Appendix H

Odour Assessment

**REVIEW OF ODOUR EFFECTS RELATING TO HOLMES AND SKELLERUP BLOCKS - ROLLESTON
WEST PLAN CHANGE**

**RESPONSE TO REQUEST FOR FURTHER INFORMATION – PC200073 – PRIVATE PLAN CHANGE
REQUEST TO THE OPERATIVE SELWYN DISTRICT PLAN FROM ROLLESTON WEST RESIDENTIAL
LIMITED IN ROLLESTON**

Figure 1: Recommended buffer distance for Skellerup block.

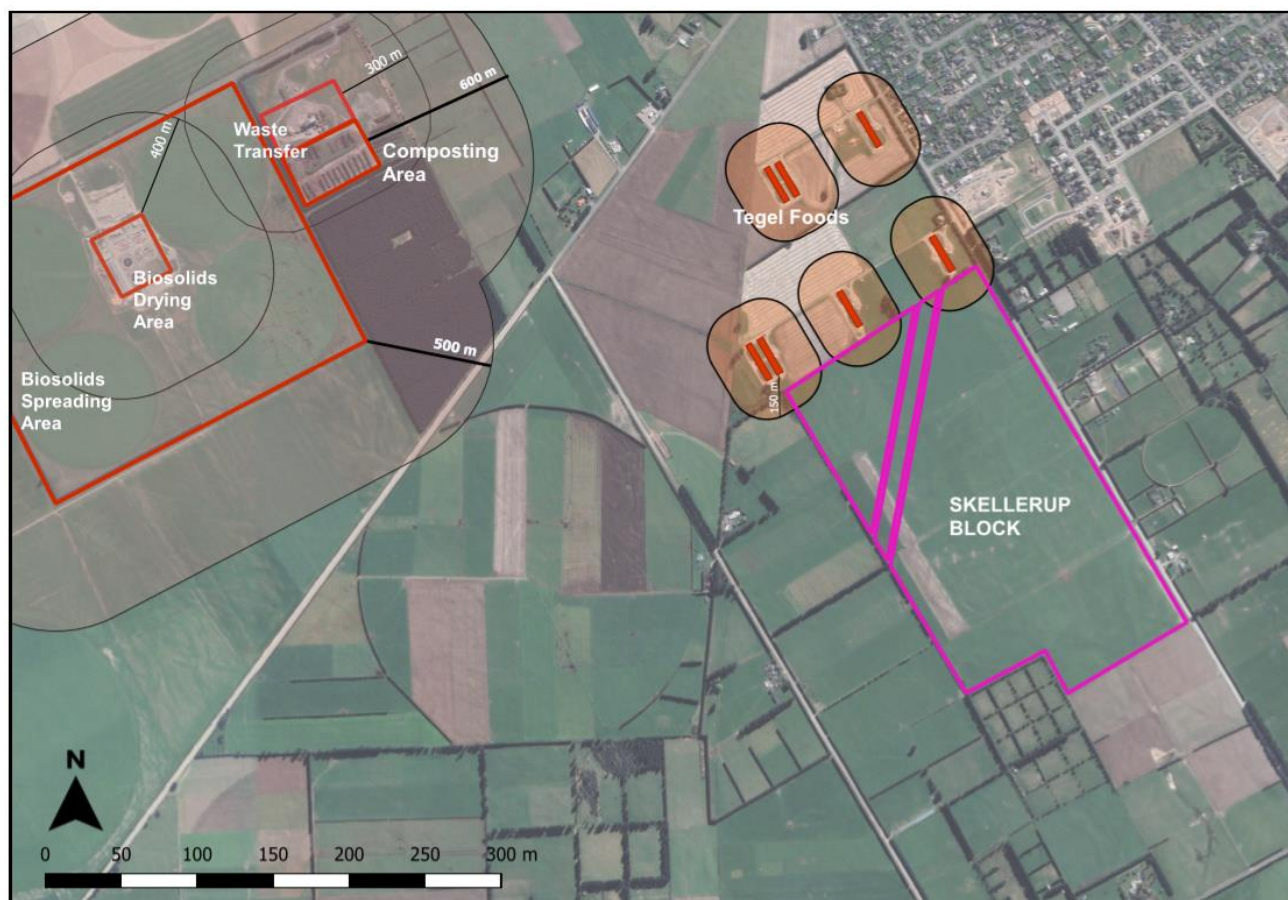
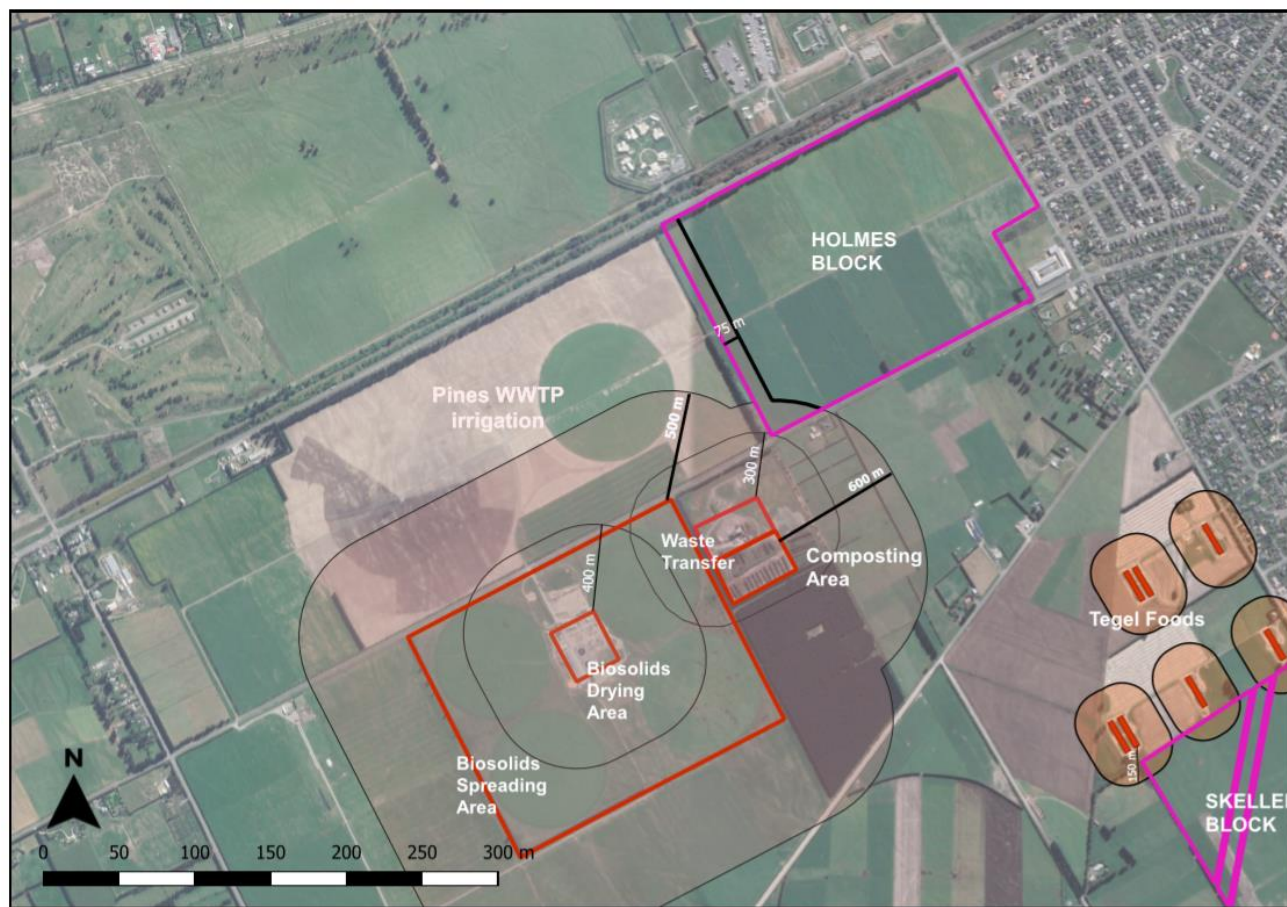
SDC request 39, Bullet 1: *The recommended buffer distances are provided in Table 1 and illustrated in the maps in Figures 1 and 2 of the Golder report dated 11 November 2020. It is noted that the distances of the buffers zones from the boundaries of the individual odour sources as drawn on the maps appear to be less than the actual distances when measured in Google Earth (i.e. the buffers as drawn are smaller than what is measured in Google Earth). In addition, the scale bars on the maps do not agree with the actual spatial scale of the maps. It is recommended that the buffer distances in the maps be re-examined and the assessment updated as required.*

It is agreed the maps were incorrect and an updated map is attached to this letter (Figure 1). The tabulated values presented have been maintained.

TITLE
SITE PLAN - CURRENT AND PROPOSED ACTIVITIES

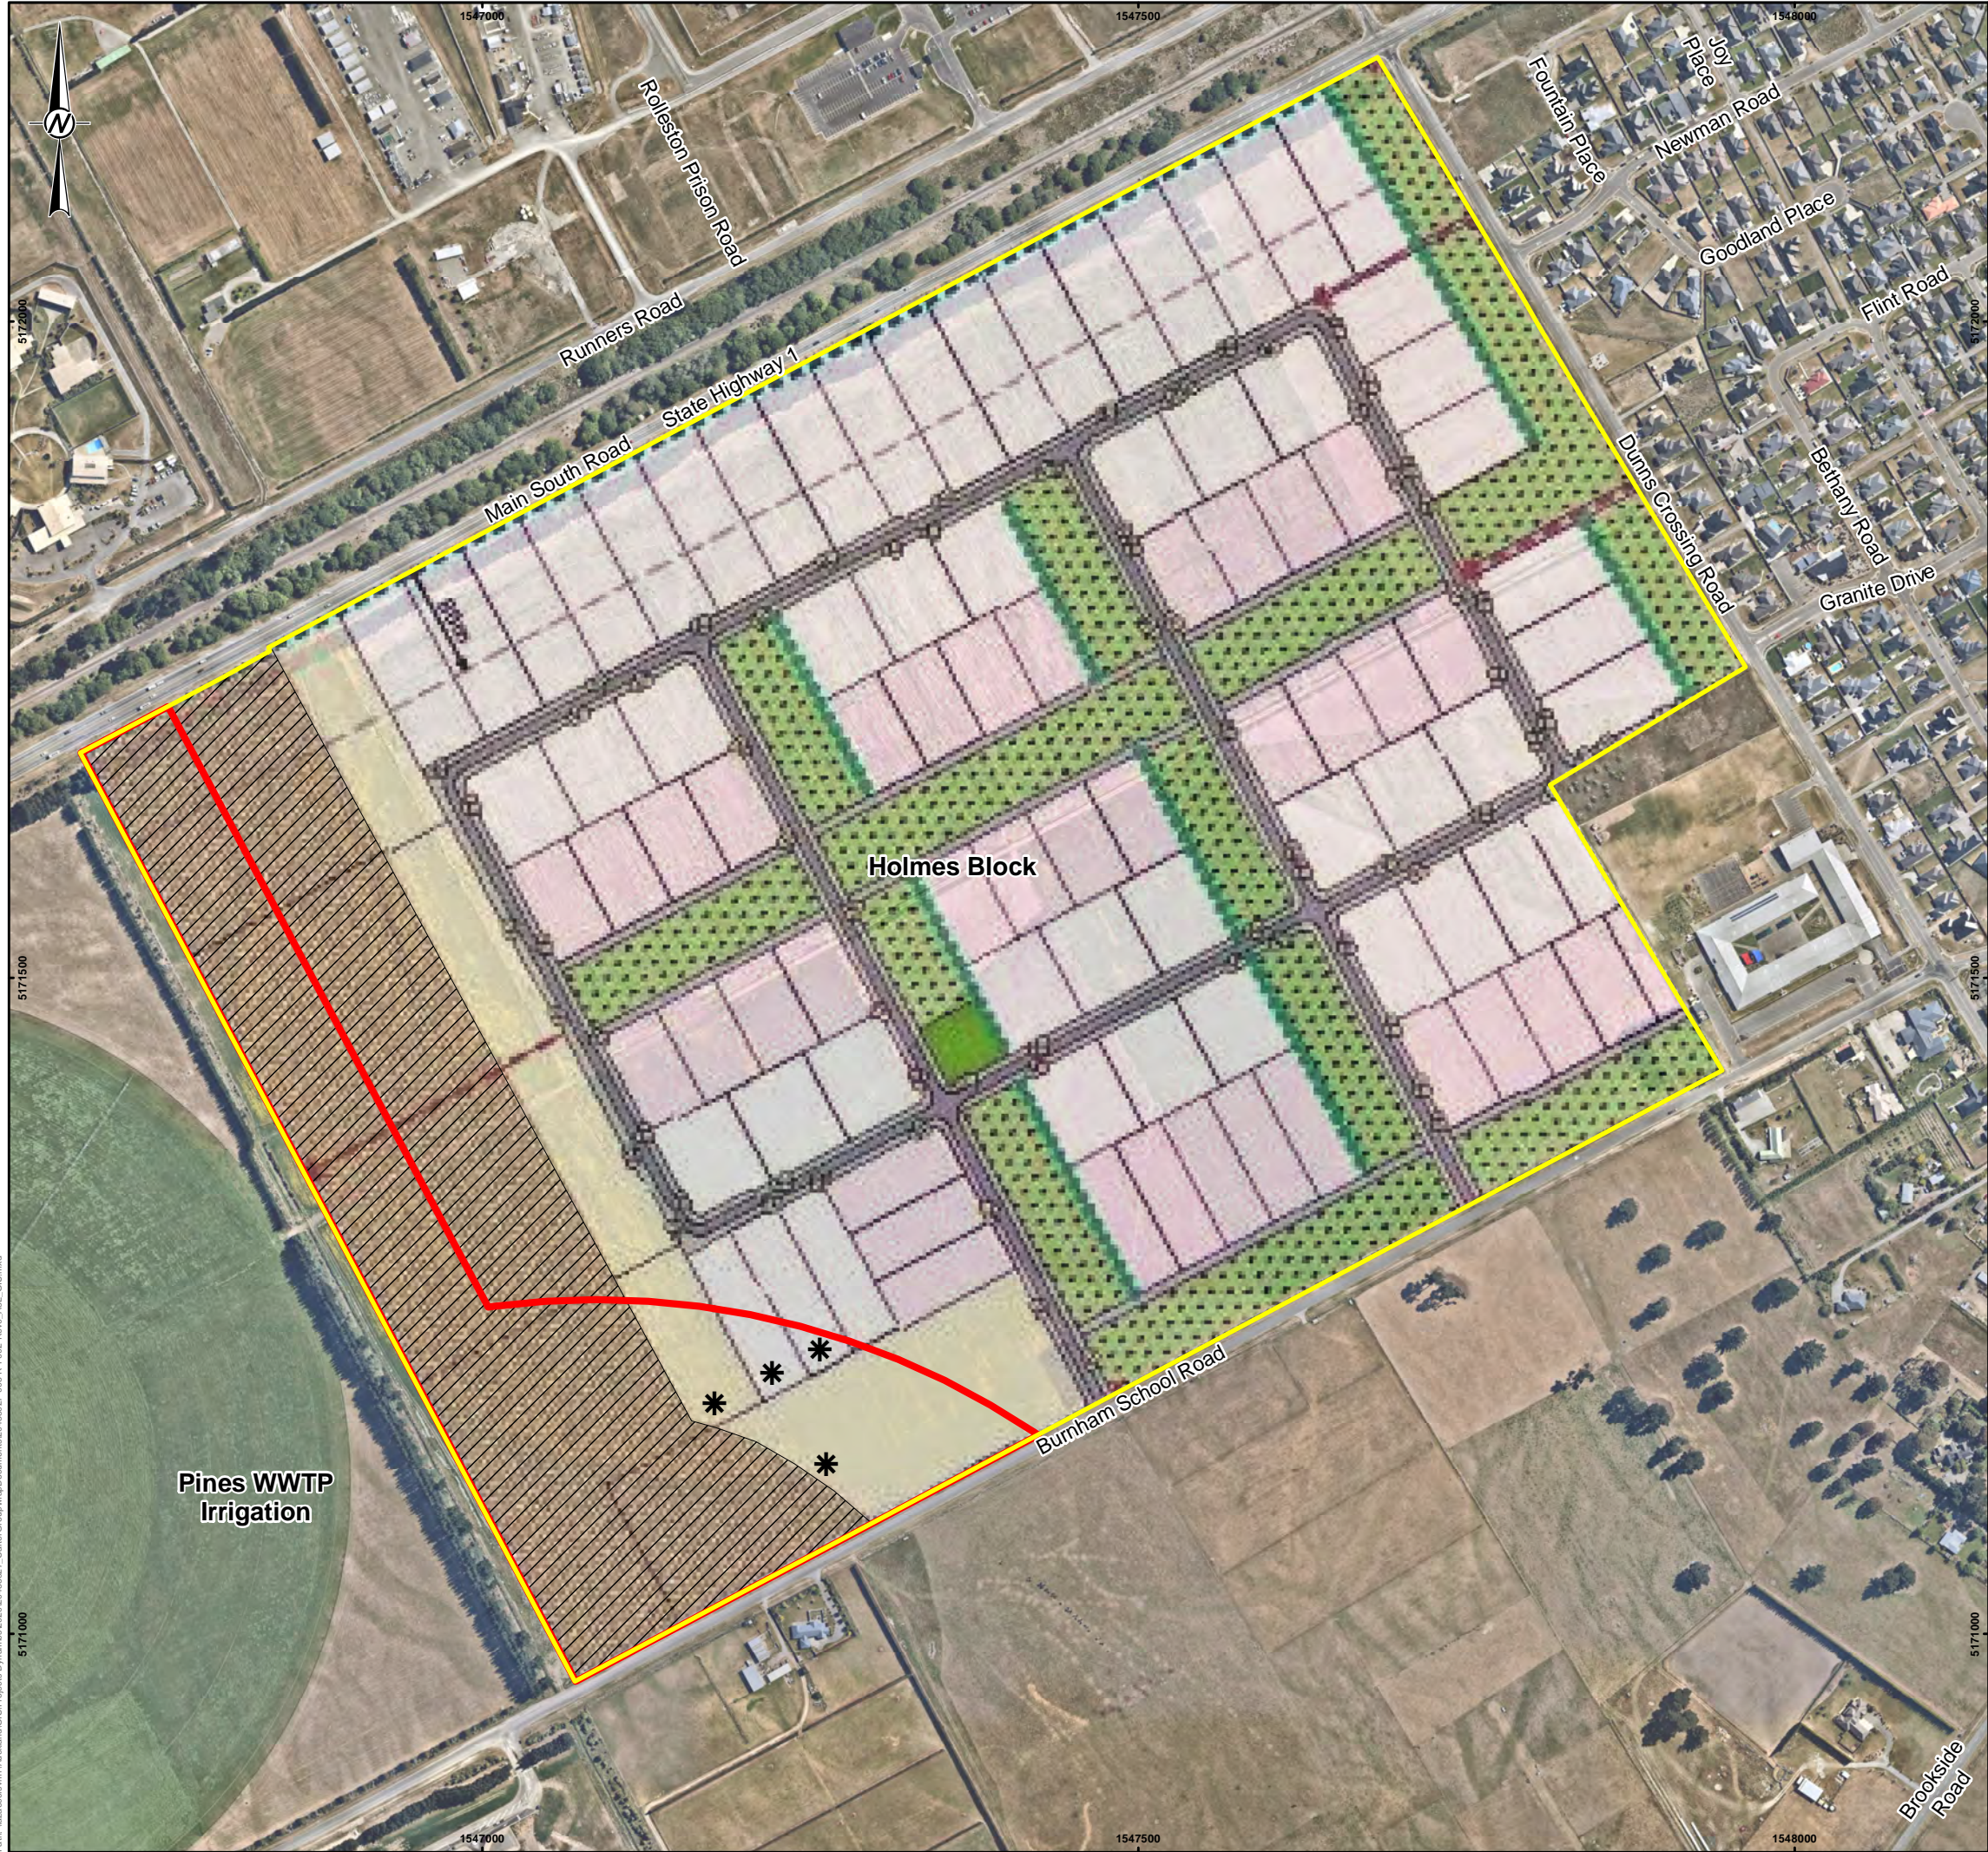
SDC Paragraph 8. *In relation to the RRP, the Odour Assessment recommends a buffer distance of 600m from the composting operation, based on the volume of compost throughput at the site in 2018, while acknowledging that the scale of the operation is not constrained. Given that the scale of composting at the RRP is expected to increase given the population growth in Selwyn, how will this affect the recommended buffer distance in order to prevent reverse sensitivity effects? Additionally the reference to an existing dwelling located 600m from the composting operation is noted. This is a rural dwelling on 20ha zoned Rural (Outer Plains). Clarification is sought about the potential difference in sensitivity of a rural dwelling vs a suburban dwelling of a scale and character proposed by the plan change request.*

The operative plan allows for four dwellings to be built within 600 m of the composting operation in a large block living zone (see attached Figure 2). We consider additional houses within 600m of the composting operation is likely, from a probability perspective, to increase the likelihood of reverse sensitivity odour effects. Therefore, our recommendation is that no additional dwellings are built within 600 m of the composting operation to avoid reverse sensitivity effects. We note that this outcome would avoid reverse sensitivity effects to a greater degree than the status quo, insofar that the proposed change would result in four fewer houses being located within the 600m buffer distance from the composting operation.
